<b>Office Action Summary</b>	<b>Application No.</b> 10/580,196	<b>Applicant(s)</b> GALLATZ ET AL.	
	<b>Examiner</b> KEITH COLEMAN	<b>Art Unit</b> 3747

## DETAILED ACTION

4. Claims 25-30 are rejected under 35 U.S.C. 103(a) as being unpatentable over Ward (US Patent No. 4,138,890).

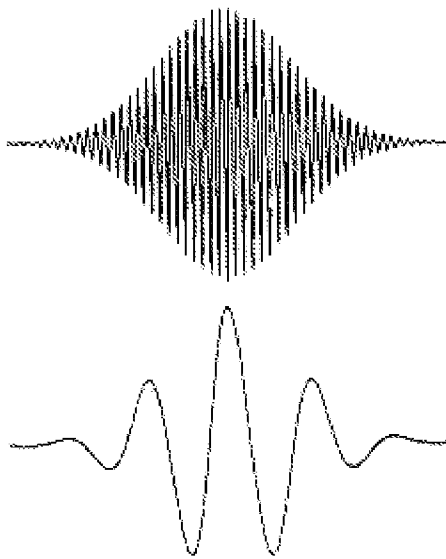
Furthermore, Applicant simply elides over the basic components of a waveform. As shown below, ostensibly, changing the frequency of the wave will change the spacing between peaks and the patent to Ward clearly discloses changing frequencies.
